Flynn Building

Town of Sudbury ADA Transition Plan

December 2020

Institute for Human Centered Design

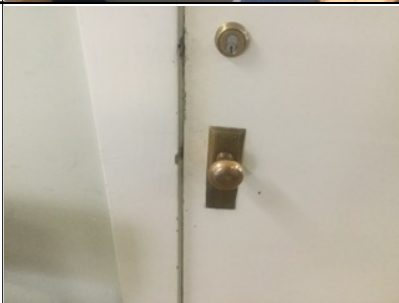
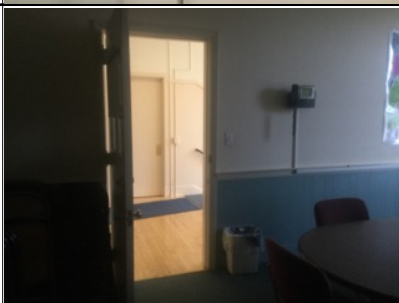
4	Accessible Entrance at North Stair	G		Entrance	Main Entrance		Mat not securely attached	-	Secure the mat.	1	Labor	\$0

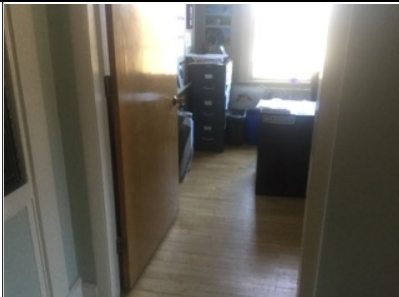
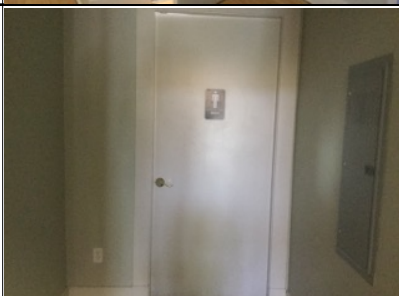
14	Human Resources (West Office) Path to Human Resources & Assistant Town Manager	2		Doors, Doorways, & Gates	Office		Maneuvering clearance(s) not provided	43.75"	Relocate file cabinet to provide 60" deep of maneuvering clearance at door.	1	Labor	\$0

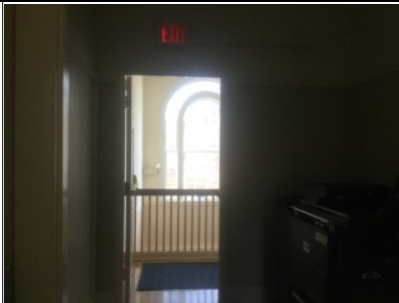
24	Human Resources (East Office)	2		Doors, Doorways, & Gates	Office		Hardware not operable with a closed fist	-	Provide hardware that can be operable with one hand and not require tight grasping, pinching, or twisting of the wrist.	1	484	\$484

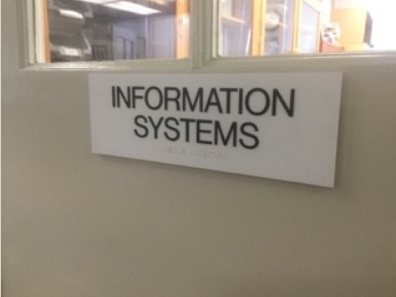
29	Men's Toilet Room	1		Doors, Doorways, & Gates	Toilet Room		Hardware not operable with a closed fist Door requires > 5 lbs. of force to open	- 11 lbs.	Provide hardware that can be operable with one hand and not require tight grasping, pinching, or twisting of the wrist. Adjust closers so doors do not require more than 5 pounds of force to open.	1	484 Labor	\$484

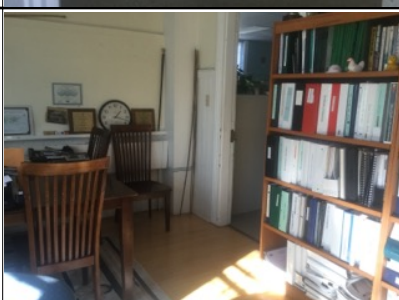
39	Credit Union	2		Signage	Designation		Raised characters not provided on sign Braille not provided on sign	- -	Provide text with raised characters duplicated in braille on sign.	1	232	\$232

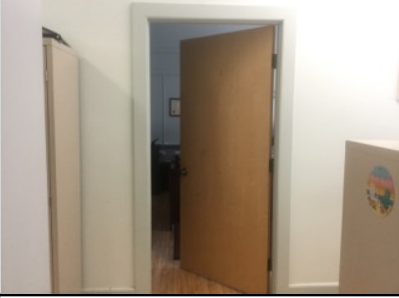
49	Planning & Community Development	2		Operable Parts	Clothes Rod/Hooks		Reach < 15" or > 48"(forward/side approach)	66"	Provide one coat hook no higher than 48" max. above the finished floor.	1	150	\$150
